ARLINGTON COUNTY, VIRGINIA

ARLINGTON COUNTY PLANNING COMMISSION

July 19, 2012

- C. **SP#419** JBG/Rosslyn Gateway North, L.L.C. for a phased development site plan for the construction of a 498,744 sq. ft. commercial building with 490,056 sq. ft. of office space and 8,688 sq. ft. of ground floor retail, a 316,616 sq. ft. building with 172,663 sq. ft. of residential use, 133,952 sq. ft. of hotel use and 10,001 sq. ft. of retail space, and a 143,910 sq. ft. building consisting of 136,223 sq. ft. of residential use and 7,687 sq. ft. of retail space in the C-O-Rosslyn zoning district. Property is approximately 95,927

DRAWN BY: MDR/KJC
SCALE: 1"=80'
DRAWING TITLE: LANDSCAPED OPEN SPACE EXHIBIT

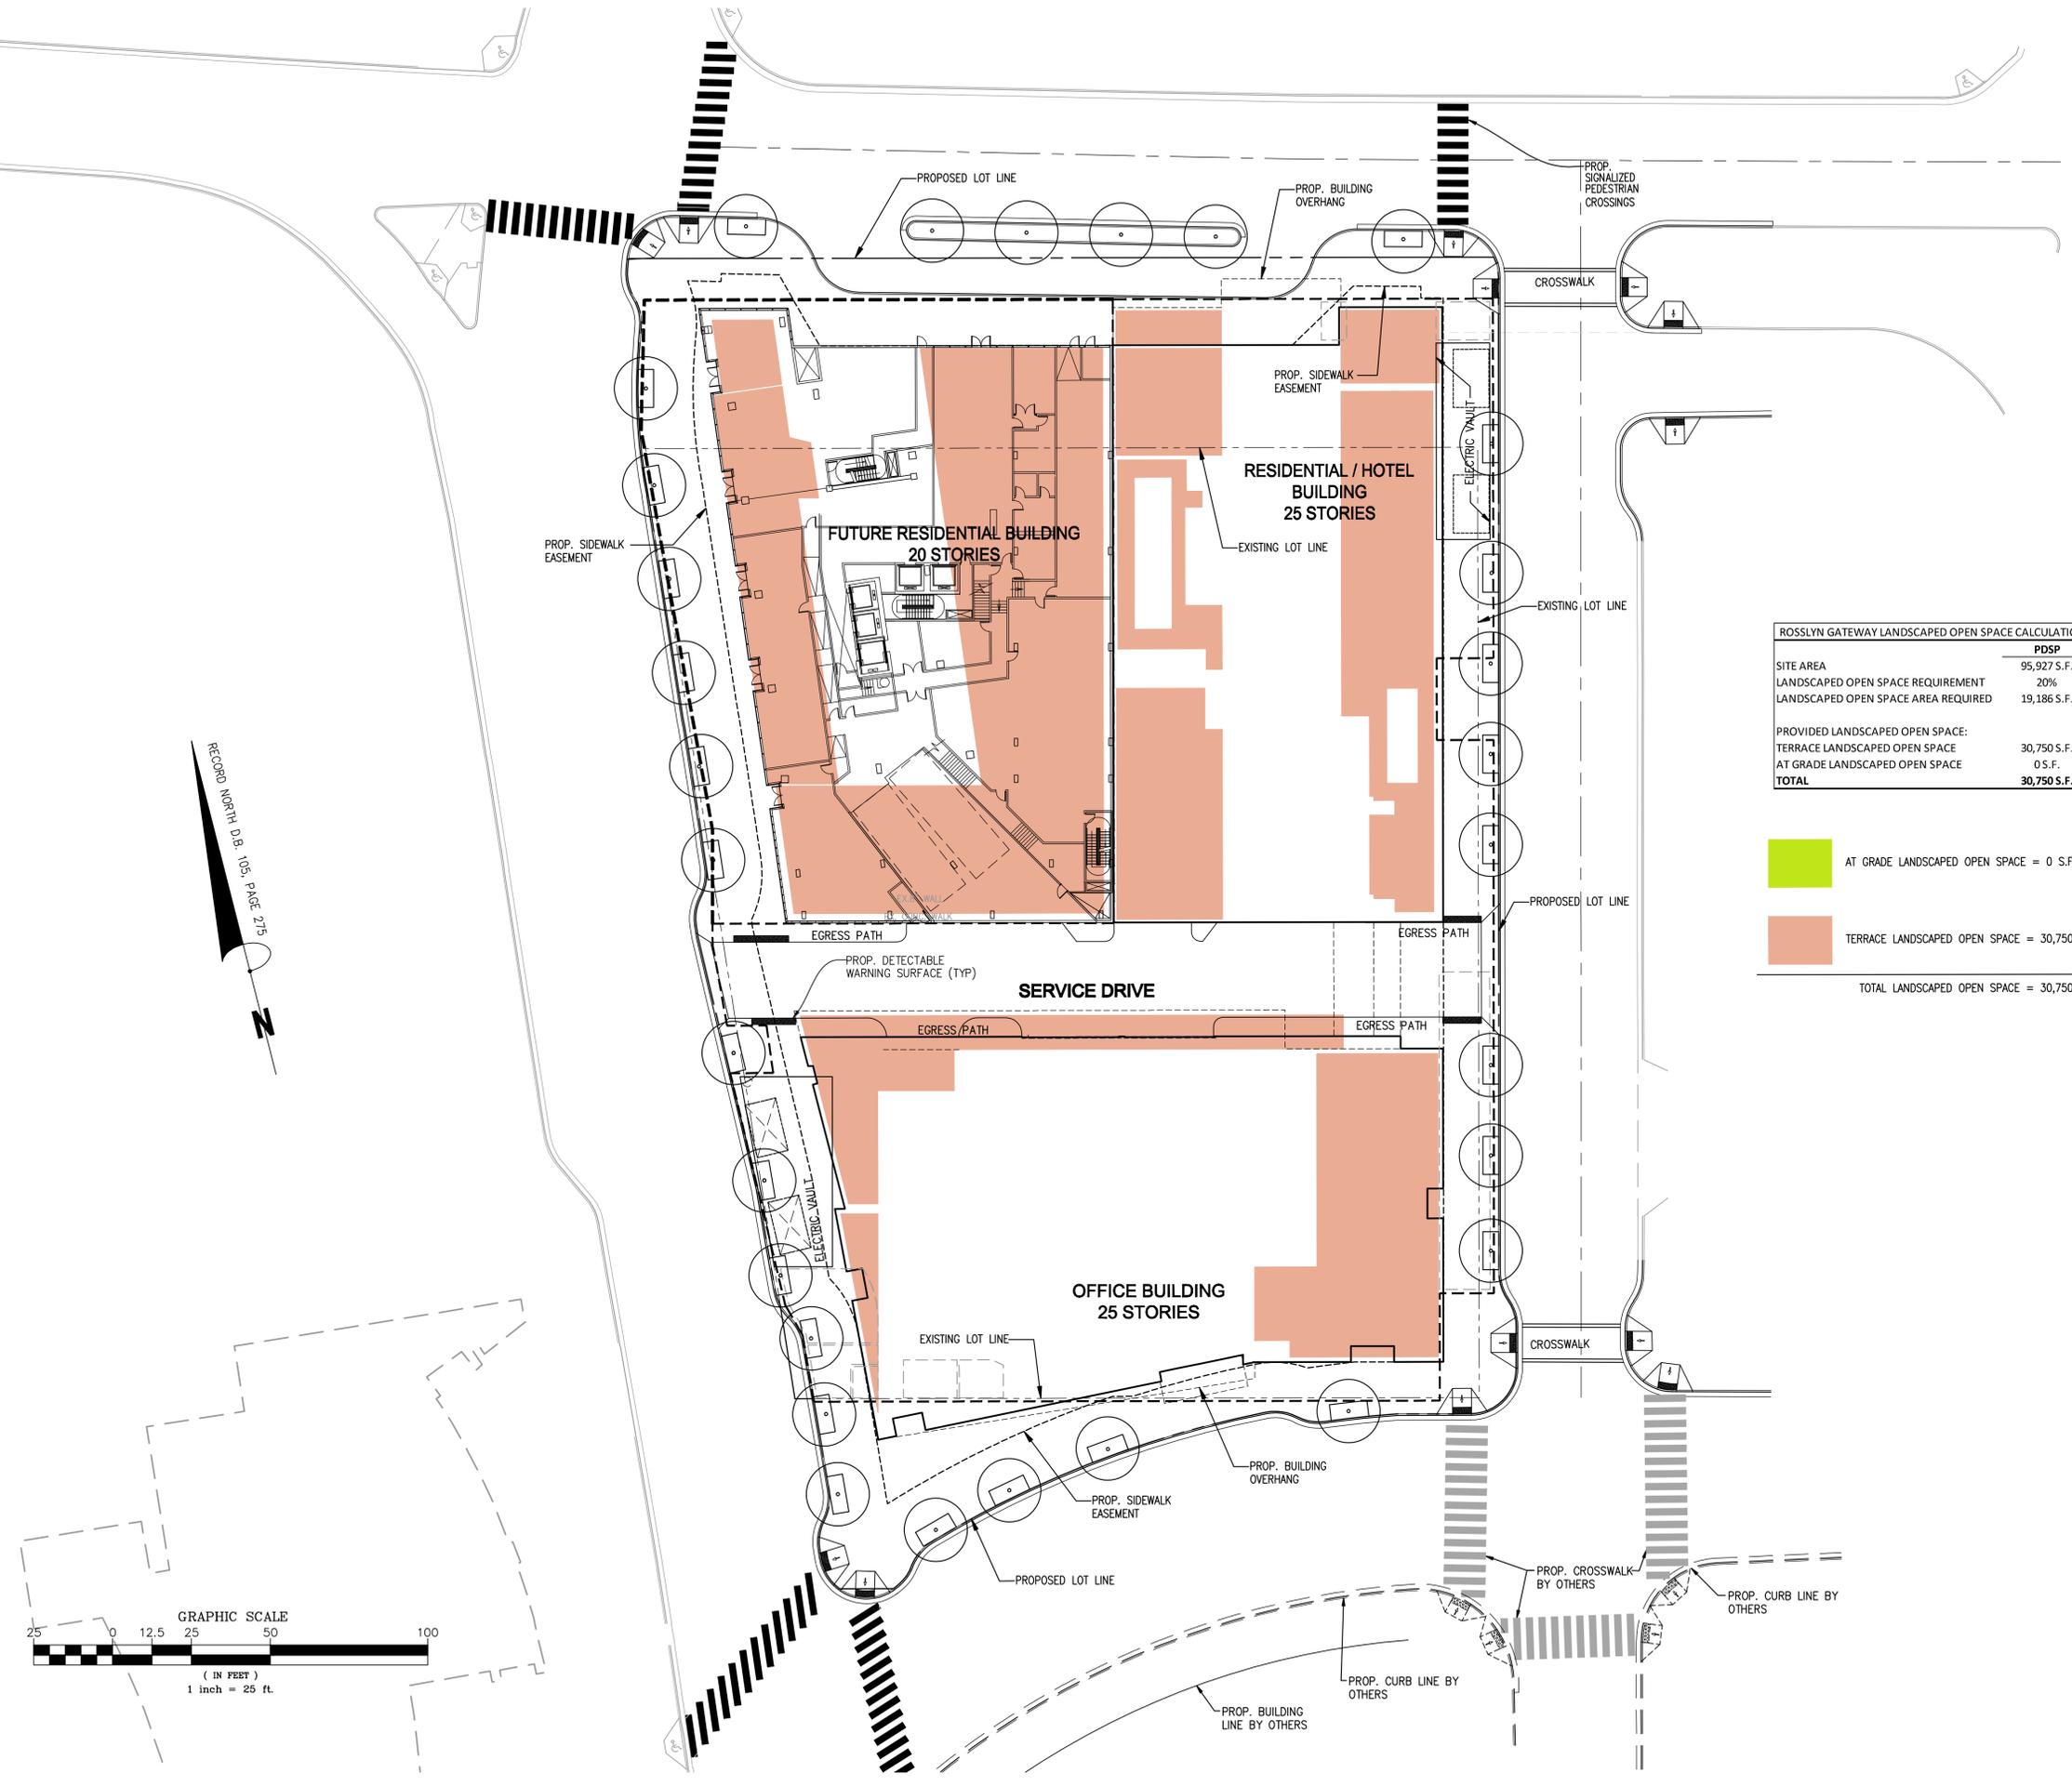
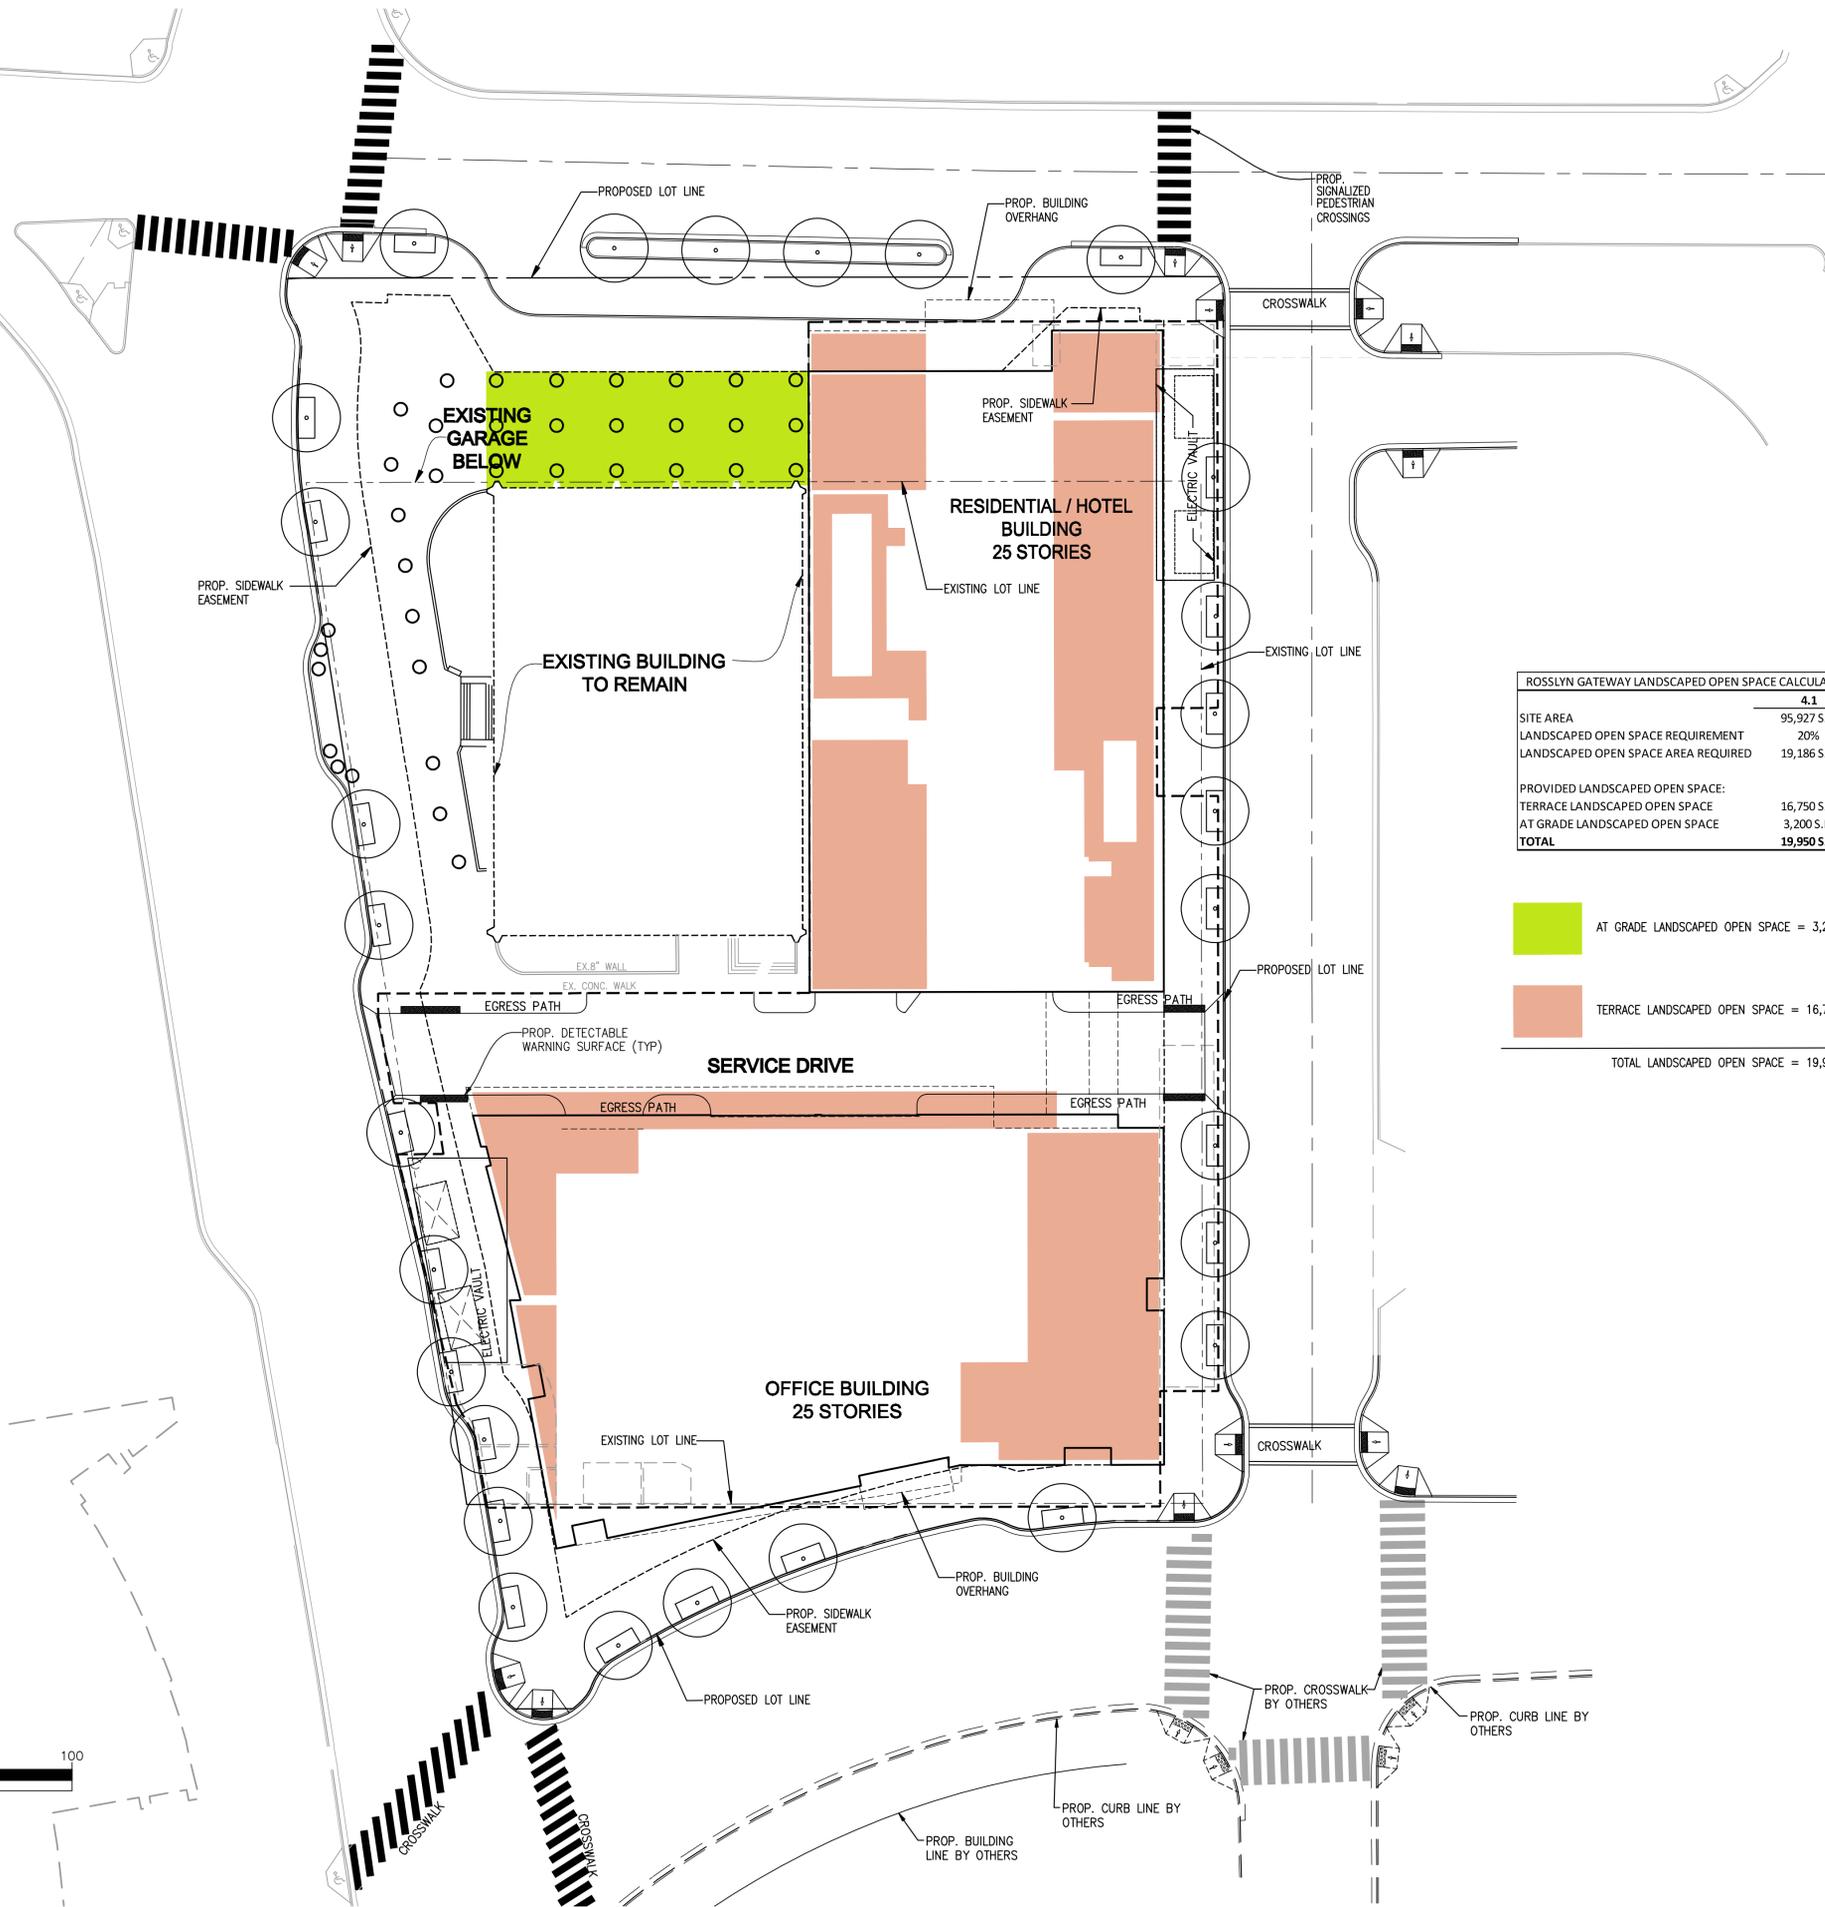
Commissioner Ciotti stated that including rooftop terraces in the required landscaped open space calculation does not seem right and could be unprecedented. They are not at grade or a part of the public realm. Mr. Shriber responded that it meets the intent of the "C-O-Rosslyn" district for landscaped areas, as the district references back to Section 32A of the Zoning Ordinance, landscaping standards, which addresses planting requirements rather than open space requirements, such as provision of pocket parks, etc. Mr. Shriber agreed to report back on how other "C-O-Rosslyn" projects have addressed this issue.

The attached Exhibits (C and D) were provided by the applicant to verify that this requirement would be satisfied with both the PDSP (32%) and FSP (21%) applications. As depicted in the exhibits, the rooftop planted terrace areas are included in these calculations, which is consistent with staff’s administrative practice regarding landscape open space calculations.
